# AMENDMENT OF SOLICITATION/MODIFICATION OF CONTRACT

2. AMENDMENT/MODIFICATION NO.:  002	3. EFFECTIVE DATE  5DEC2005	4. PURCHASE REQUISITION NO.:  NA	5A. SOLICITATION/CONTRACT/PROJECT TITLE
			5B. PROJECT NO (If applicable)
6. ISSUED BY  <b>ARCHITECT OF THE CAPITOL</b> United States Capitol Washington, D.C. 20515		7. ADDRESS AMENDMENT/MODIFICATION TO Architect of the Capitol Procurement Division Ford House Office Building, Room H2-263 Attn: CAROLYN HORNE (202) 226-1940 Second and "D" Streets, S.W. Washington, DC 20515	
8. NAME AND ADDRESS OF CONTRACTOR (No., Street, County, State and Zip Code)  <b>TO ALL CONTRACTORS</b>		(X)	9A. AMENDMENT OF SOLICITATION NO. AOC050104
			9B. DATED (See Item 11) 11OCT2005
			10A. MODIFICATION OF CONTRACT/ORDER NO.
			10B. DATED (See Item 13)

**AOC SOLICITATION NUMBER RFP050104  
SENATE WAREHOUSE FACILITY - LANDOVER, MD**

**QUESTIONS/ANSWERS**

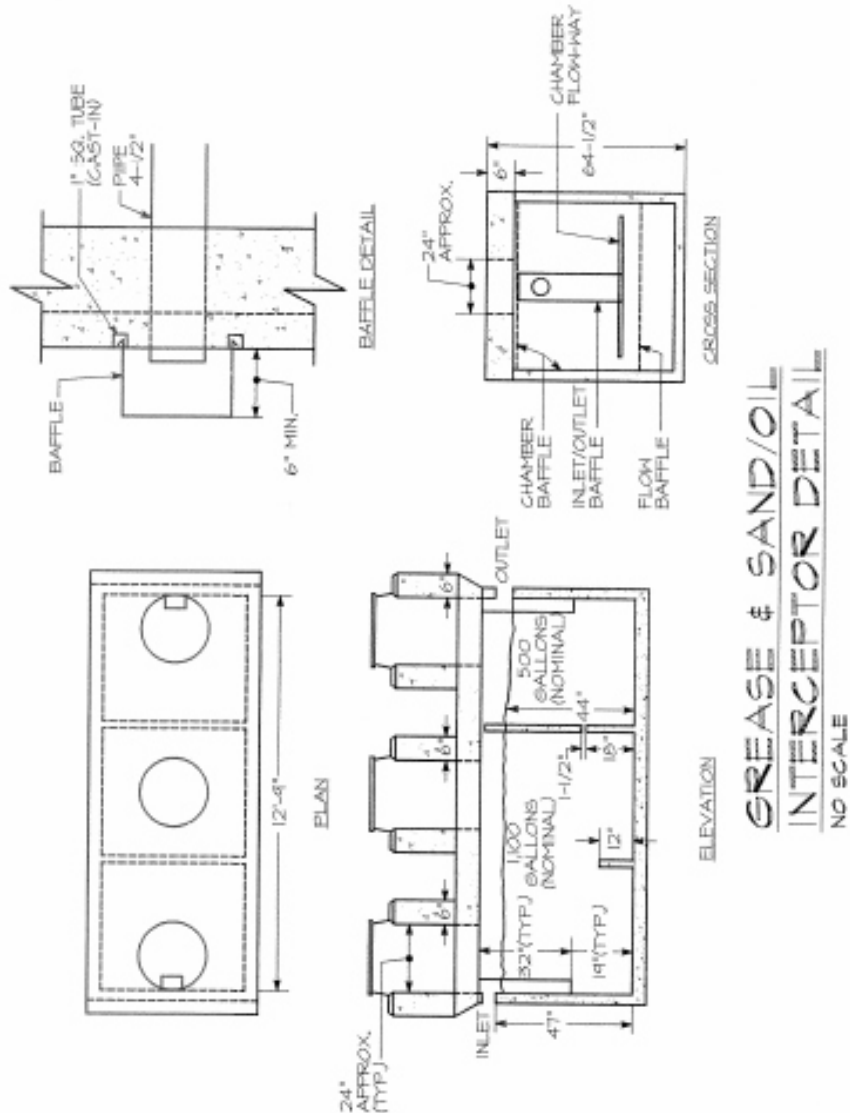
56. Please give details on the grease and oil interceptor (Attachment J6, Page 2)?

(See below)
